**Meridian Airport Authority, Dean Aircraft Services
Hangar Additions & Alterations**

ADDENDUM NO. 4

TO: All Bidders on the Above Referenced Product
FROM: Davis Purdy Architects, PLLC
DATE: April 5, 2021
SUBJECT: **ADDENDUM NO. 4**

2 ALTERNATE 4 - LEVEL 02 FLOOR PLAN
1/8" = 1'-0"

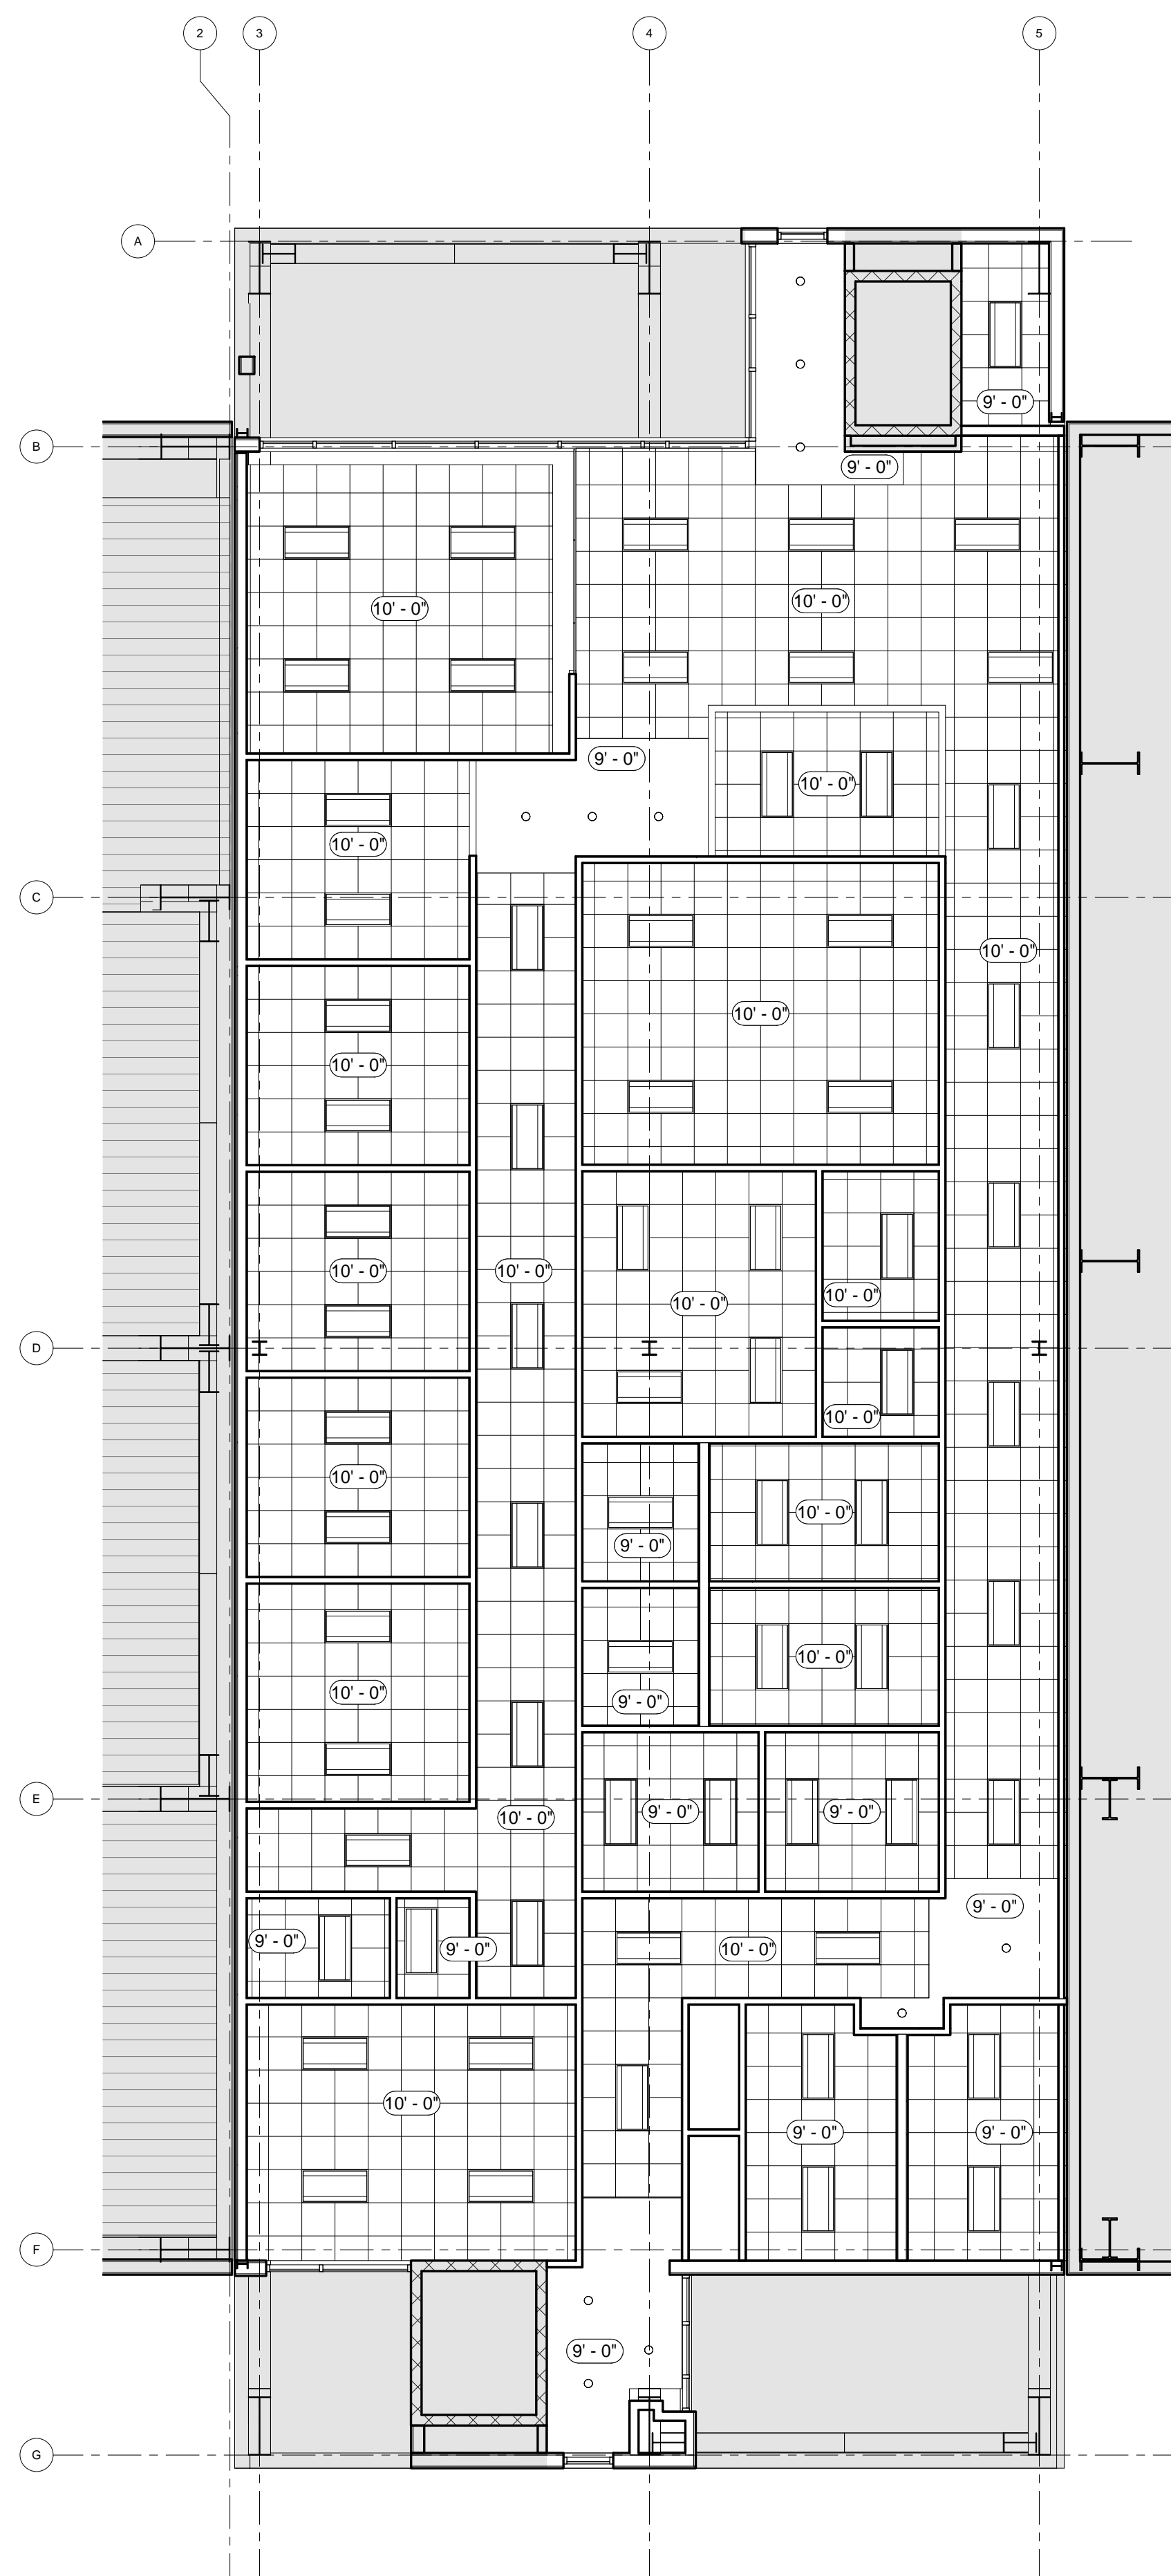
9. **REPLACE:** Replace Architectural sheet **A-800** dated 3/3/21 with the same sheets dated 4/5/21. Minor changes are indicated with clouds on sheets along with a written narrative (Dean Hangar – Addendum #4 Narrative). Architectural sheet A-800 is attached.

10. **CLARIFICATION:** Partition types shown on Architectural sheet A-800 shall extend 12” minimum above ceiling. Contractor shall provide bracing as required to stabilize partitions.

11. **CLARIFICATION:** Architectural sheets A-602 and A-800 indicate toilet rooms receiving tile walls. Provide tile on fixture walls only extending from floor to ceiling.

WALL TAGS HAVE BEEN ADDED TO PLANS

E-005

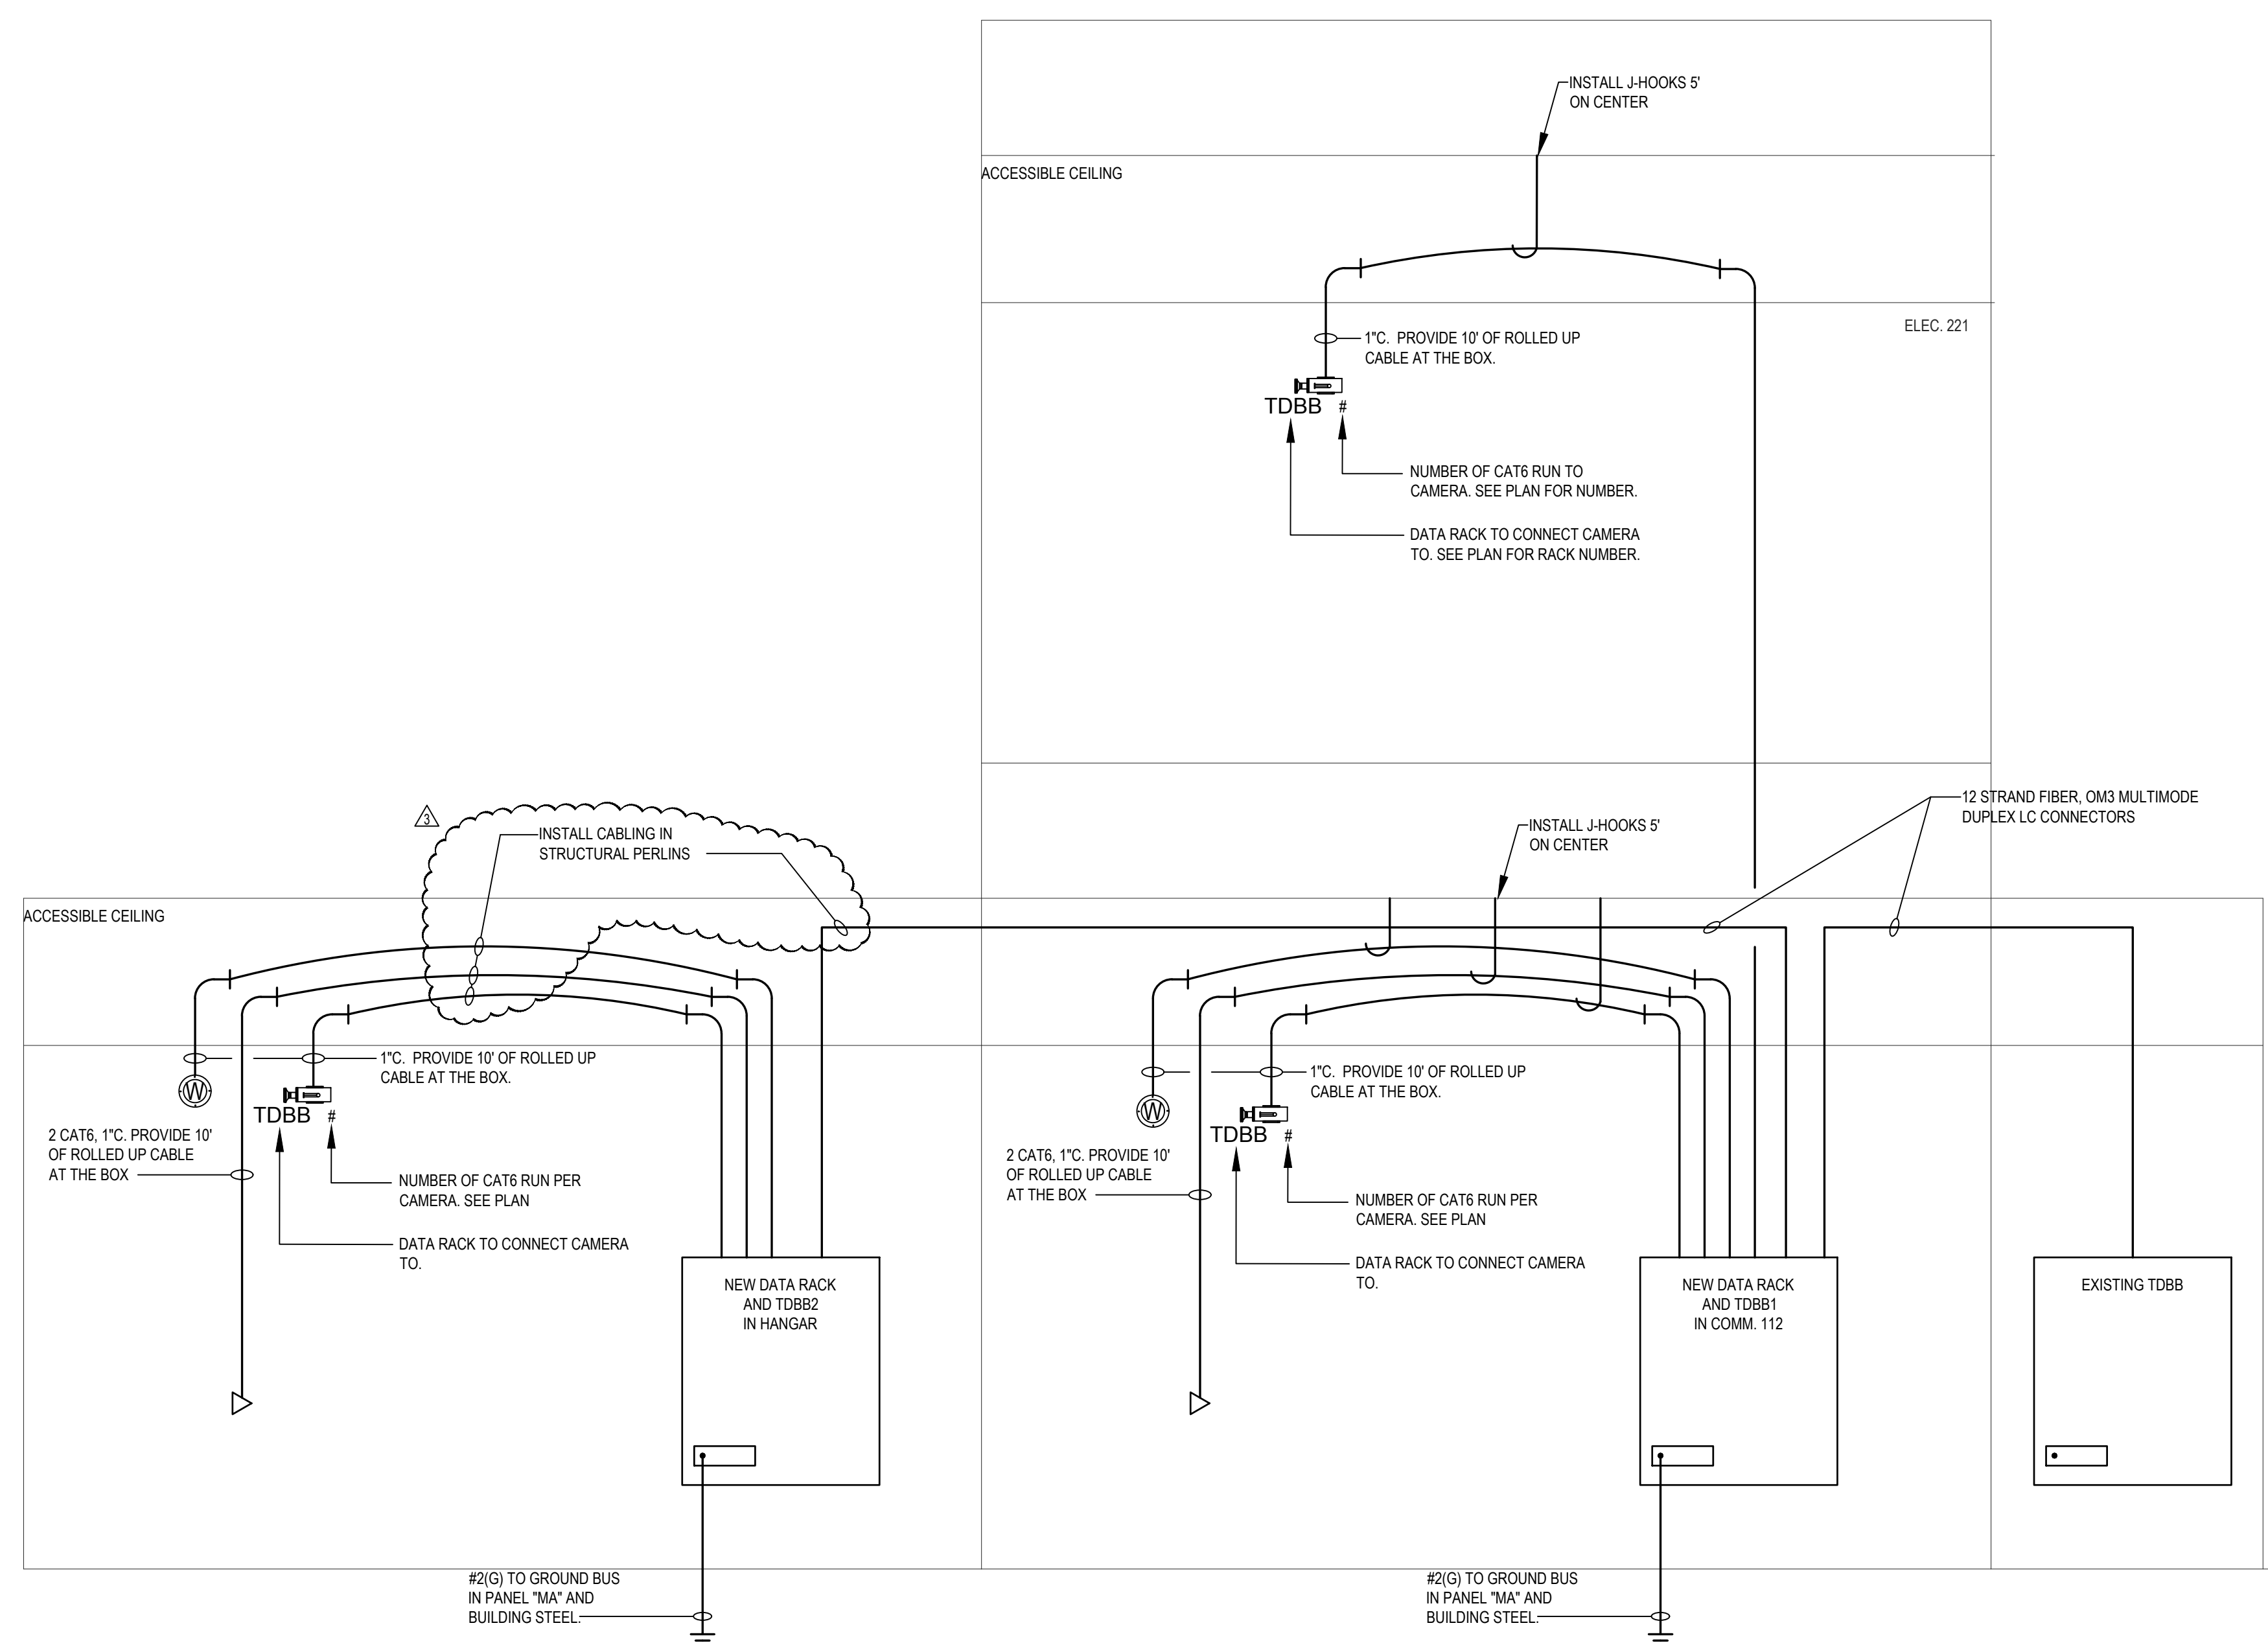
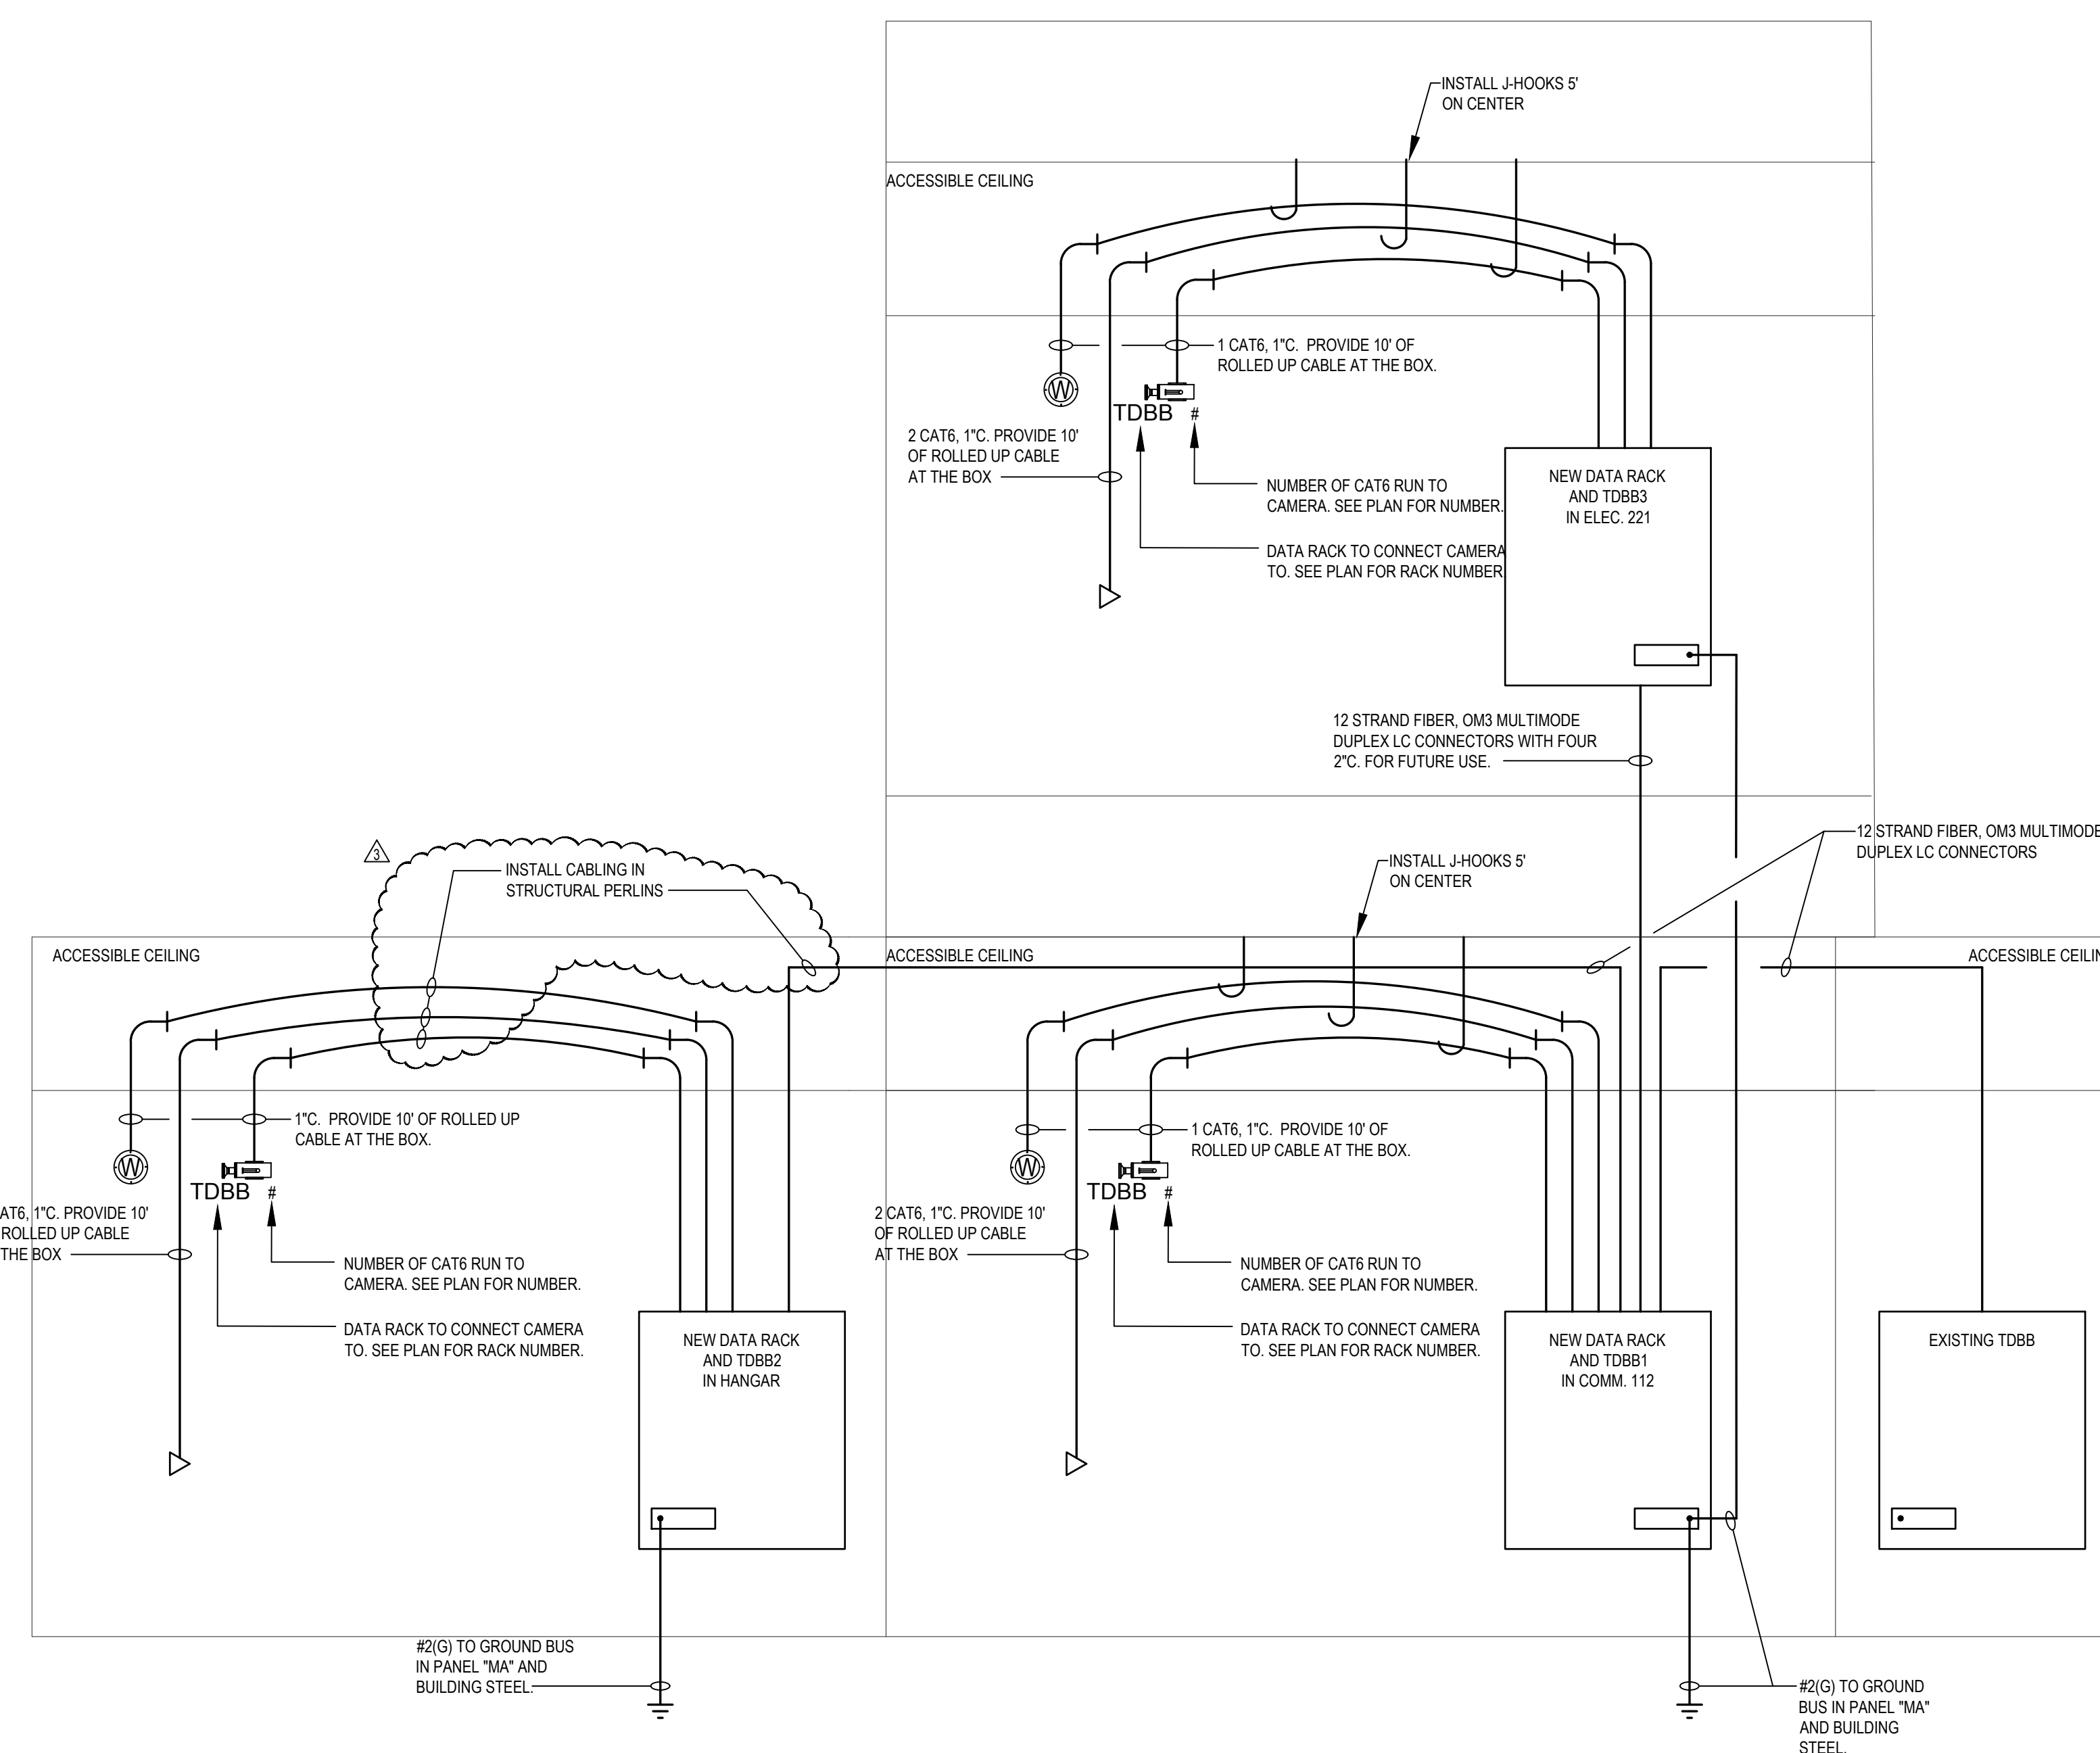
E-005 – Added Note to Clarify how to get cabling to TDBB#2 and devices.
